ZANCOR HOMES

KING'S RIDGE
KING CITY, ONTARIO (SOUTH)

SITE GRADING PLAN

| LOT NUMBERS | 71 |

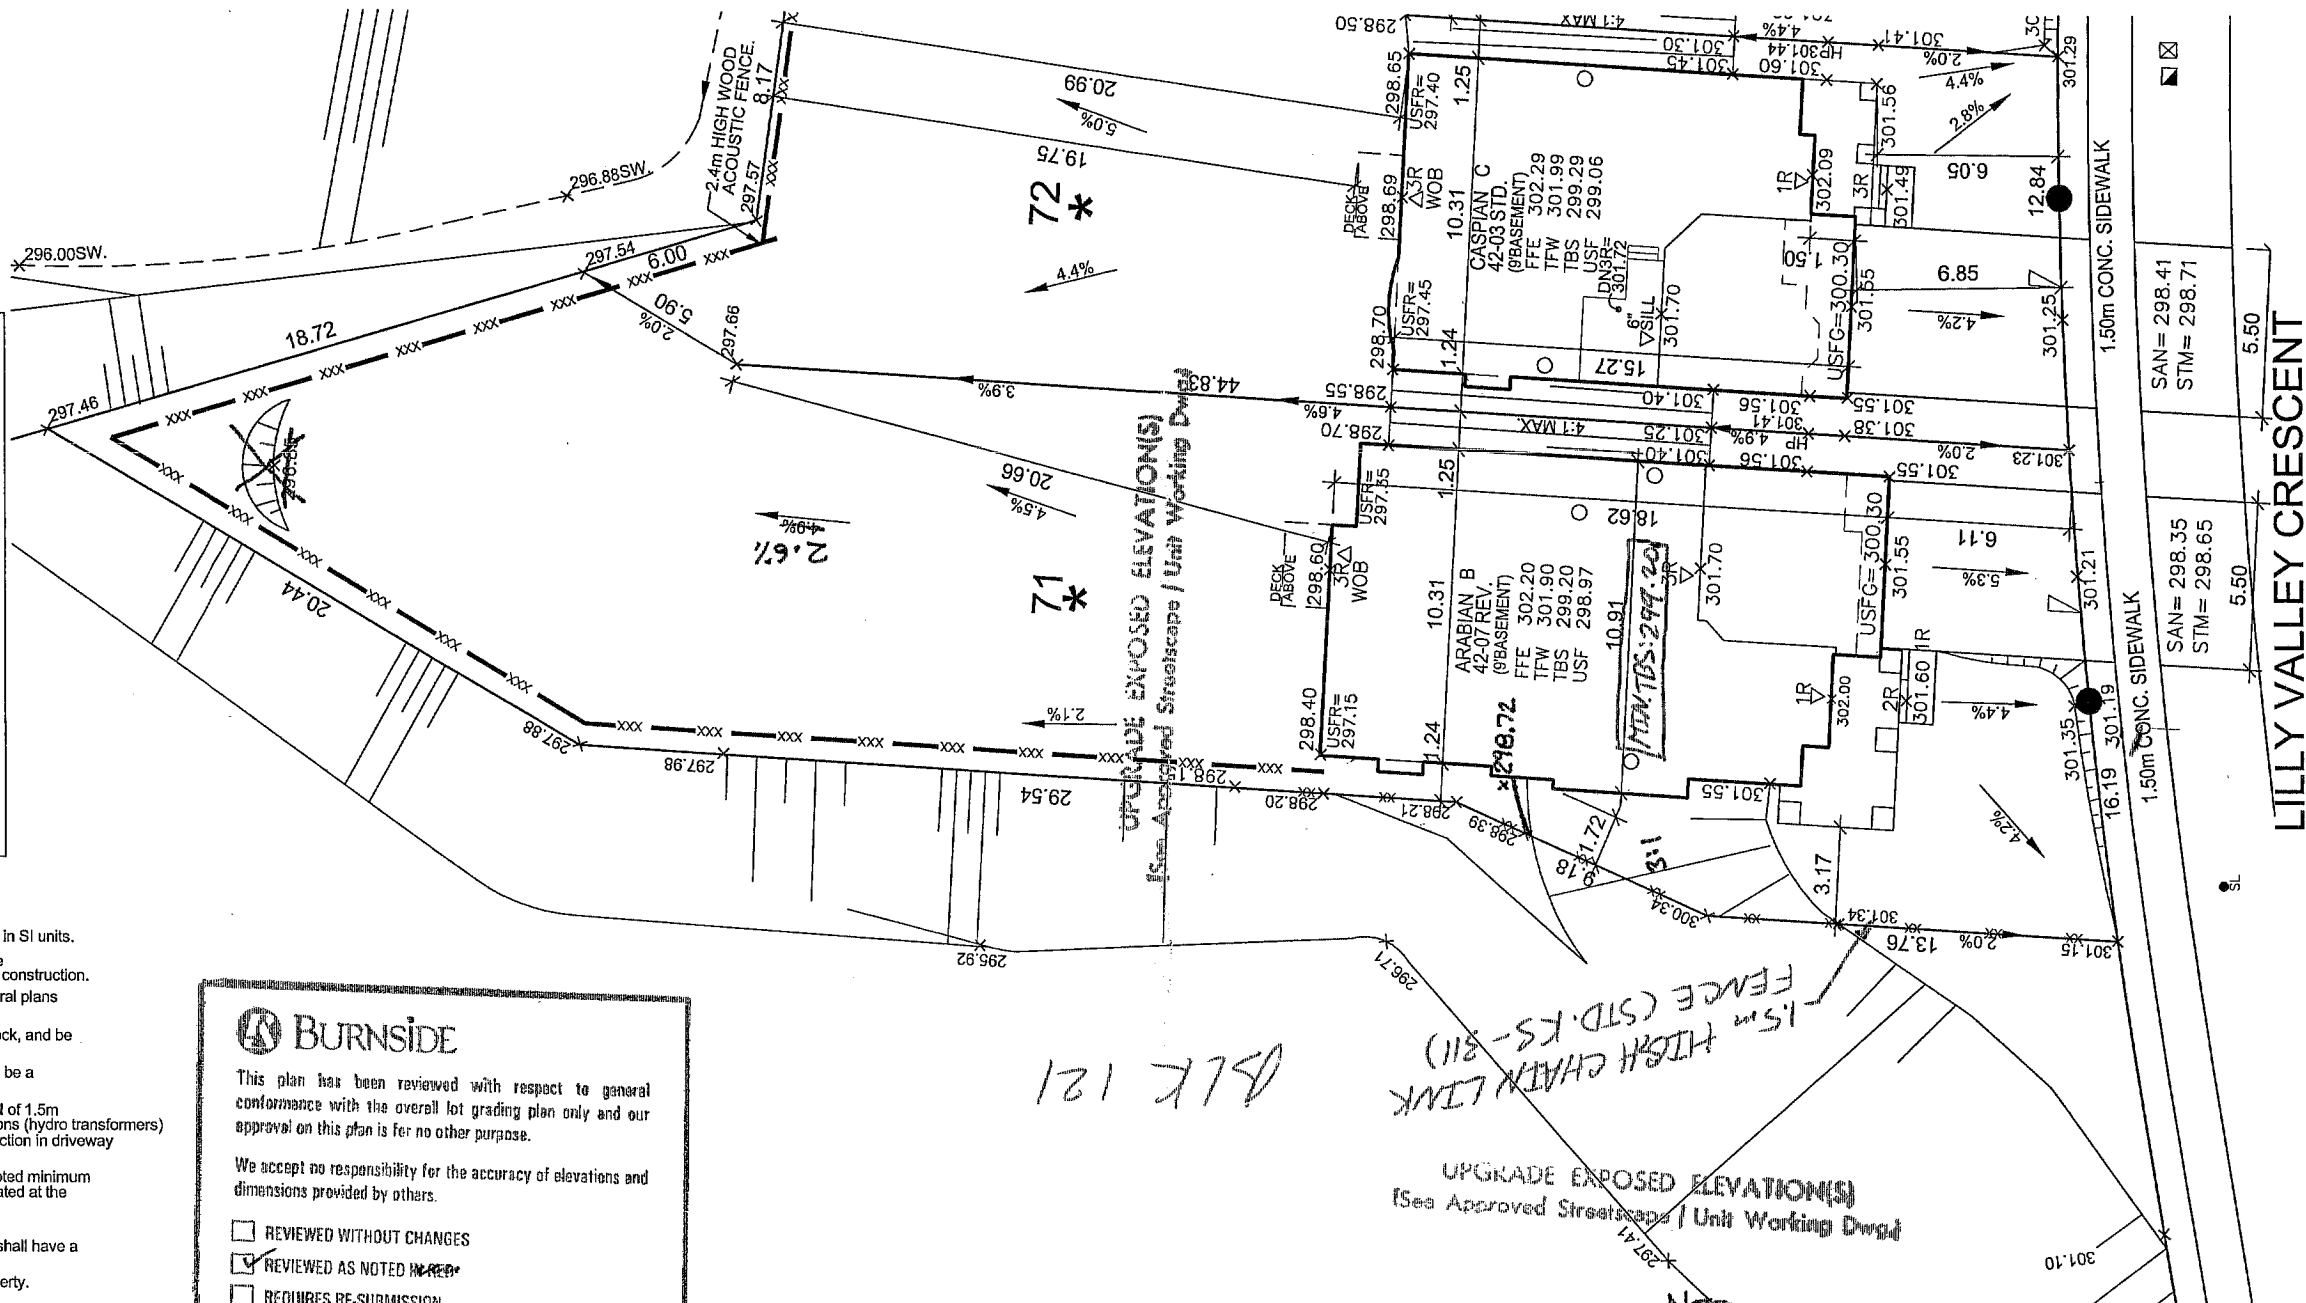
- Builder to verify storm and sanitary service lateral elevations prior to pouring footings
- Extend footings at front to ensure 1.25M cover (Min)
- Garage footings to extend to original ground or as directed by soils engineer.

- ☐ REVIEWED WITHOUT CHANGES
☒ REVIEWED AS NOTED ~~IN RED~~
☐ REQUIRES RE-SUBMISSION

NOTE: SANITARY SERVICE IS FLAT (<2.0% MIN.)
REVIEWED AS NOTED
ZONING BY-LAW 74-53 AS AMENDED
DATE: May 31/13
REF. APPL. No. 2013-337
BY: K.E. (CR4)
TOWNSHIP OF KING
